Bulletin

MODEL BENTLEY MARK VI

MODIFICATION.**REAR BRAKE EQUALISER.**

FIG. 1.

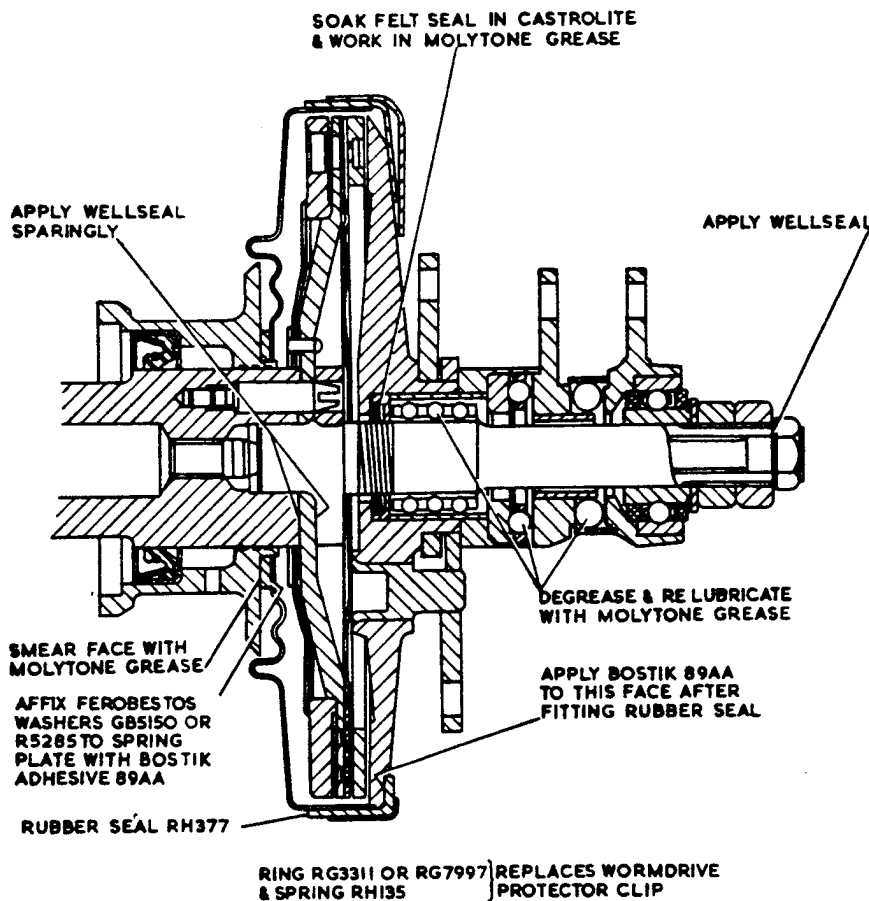
In order to ensure the fullest possible life, the servo motor sealing has been improved on production cars. Existing cars should be modified and brought to this standard, whenever a servo is dismantled.

Before re-assembling, the following modifications are required, if not already incorporated.

1. Remove the water drain on the servo spring plate, this is simply done by unsweating.
